**PROPOSED PLAN  
FOR SITE ST018  
(ALSO KNOWN AS ST-018, AOC-08,  
AND AOC08)  
COMPOSITE BUILDING SEPTIC TANK  
AND OUTFALL  
NIKOLSKI RADIO RELAY STATION**

ALASKA DEPARTMENT OF ENVIRONMENTAL CONSERVATION COMMENTS  
ON THE DRAFT PROPOSED PLAN  
AND U.S. AIR FORCE RESPONSES

Figure 3 - ST018 Site Map

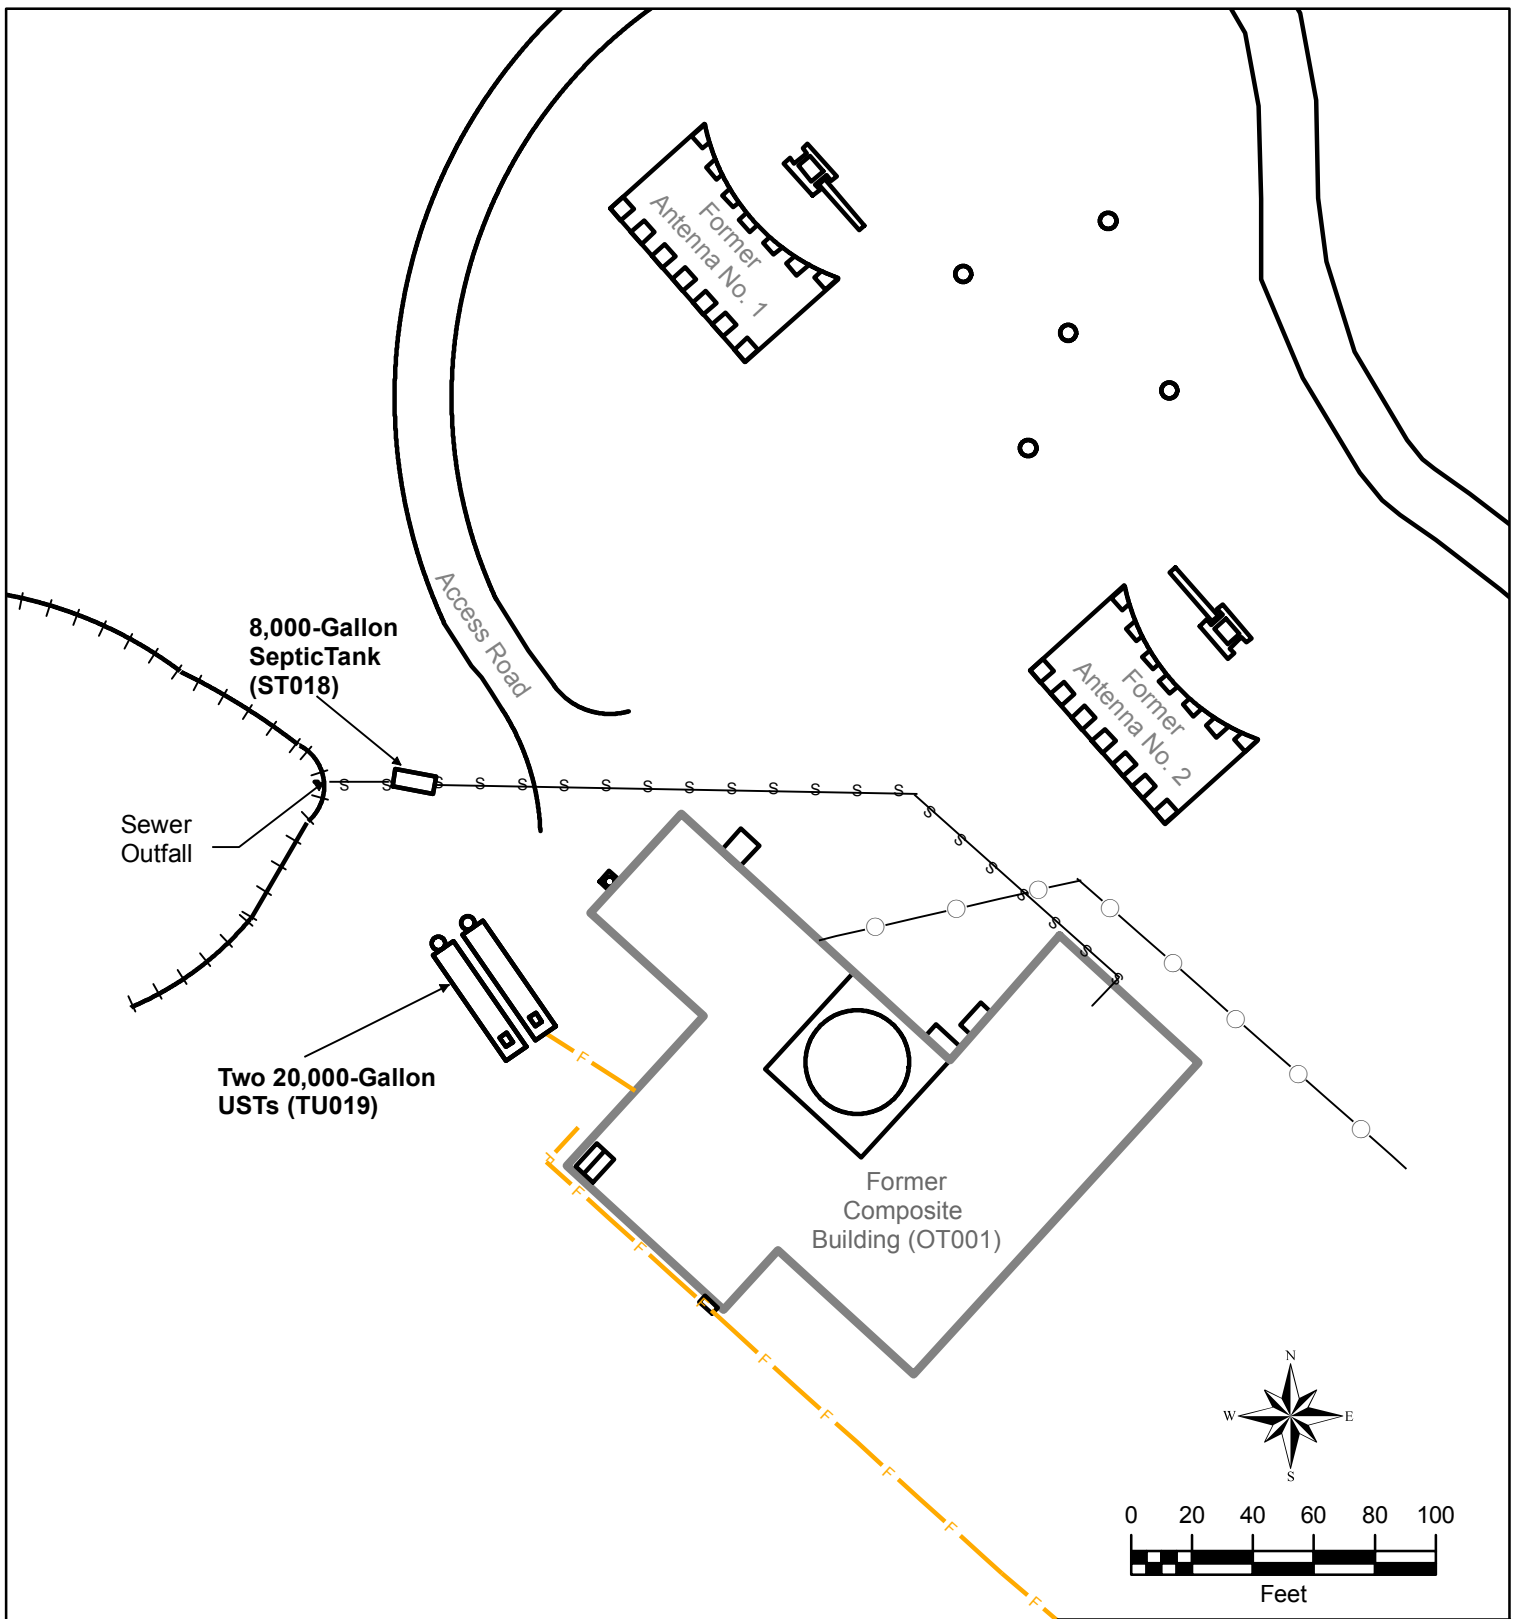
**ADEC Comment:** *DEC does not concur with a finding that no action is required to remediate contamination at this site. The septic tank poses a substantial threat of discharge of CERCLA regulated substances. The Remedial Investigation found that the tank contained TCE at 0.167 mg/l and cis-1,2 dichlorethylene at 2.69 mg/l. The feasibility study recommended the presumptive remedy of granulated activated carbon filtration for treatment of the wastewater. Hazardous substances in the tank need to be treated or disposed of properly.*

**USAF Response:** The USAF will close the septic tank in-place, and remove and properly dispose of tank contents. This will occur during the 2007 field event. Therefore, ADEC's substantive concerns will be addressed.
